October 31, 2011

Re: **Tracer Study, Plan Review # 91-2011**
Midland Water Association, PWS ID # 4101139
Final Approval

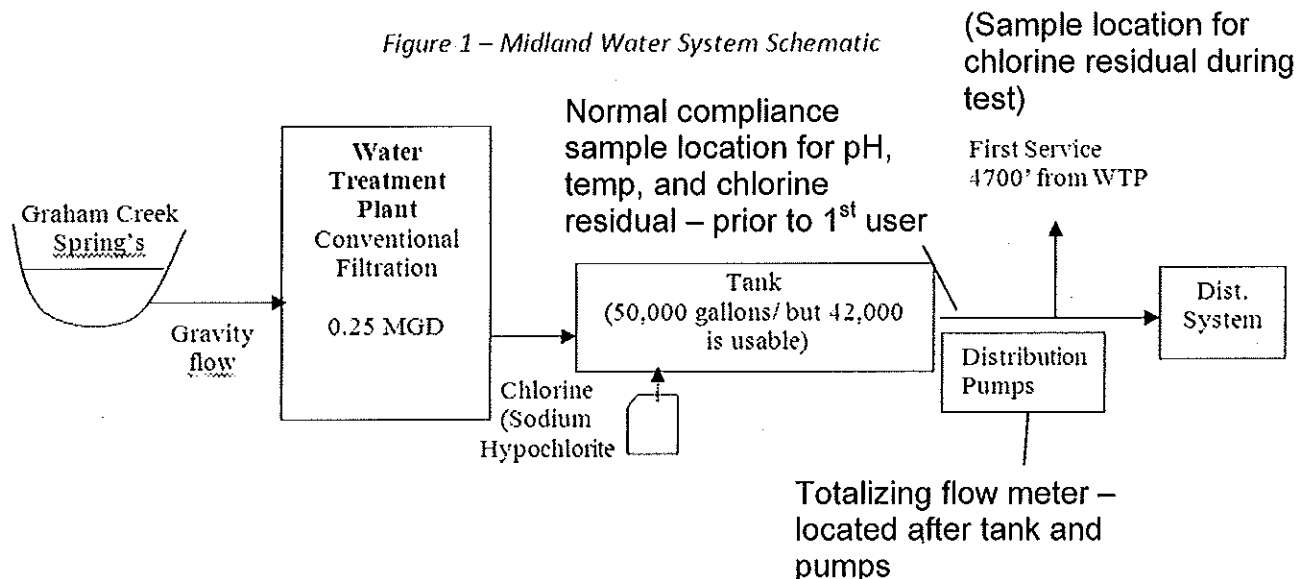
I have received and reviewed a copy of the Disinfection Contact Time Tracer Study for the Midland Water Association, prepared by the Oregon Association of Water Utilities, who is copied on this correspondence. The study was performed on May 10, 2011. Additionally, I have reviewed supplemental information submitted by Jim Kuhns, which have satisfied the conditions outlined in the May 26, 2011 conditional approval for the tracer study. **The tracer study is approved without conditions.** Mr. Kuhns is also copied on this correspondence. The schematic for the system and study are as follows:

The results for both the reservoir and length of pipeline between chlorine injection and first user, are summarized below. Please begin using the 75 minutes for contact time for

daily disinfection verification in your monthly surface water report that you submit to the Drinking Water Program (75 minutes = 42 minutes (contact time in reservoir) + 33 minutes (contact time in pipeline)):

I do have the following comments, regarding the study:

1. Continue to verify peak hourly demand flow at least once a year during peak use periods. The first condition of the May 26, 2011 letter (verifying peak hourly demand flow used during the study of 91 gpm is conservative of actual peak hourly demand flows) has been satisfied by the following supplemental monitoring of daily peak hourly demand flows measured at the flow totalizer after the tank and pumps. This measurement of actual peak hourly demand flows leaving the tank, produces values less than 91 gpm, during monitoring periods in July and August 2011. *(Note, that the tracer-study determined contact time of 75 minutes may be used as long as the peak hourly demand flow does not exceed 100 gpm, or 10 % greater than the 91 gpm value):*

2. The 75 minutes of contact time may be used as long as the minimum operating level in the reservoir does not drop below 10 % of the minimum volume during the study, or 26,960 gallons.

3. Continue to correlate the pH, temperature and chlorine residual between the current monitoring point at the treatment plant, prior to the pipeline, with the actual first user after the pipeline length. The third condition of the May 26, 2011 approval letter (verifying that chlorine residual, pH, and temperature are at least as conservative as measured at the current monitoring location, after the plant prior to the pipeline, than at the actual first user, located after the length of pipe) has been satisfied by supplemental monitoring by the Association between June and October 2011. The Association may continue to monitor these parameters at the treatment plant for disinfection verification. The results of this monitoring, outlined below indicate that measuring these parameters prior to the actual first user does not produce markedly different values, which are used to determine required CT (chlorine residual multiplied by contact time) values.
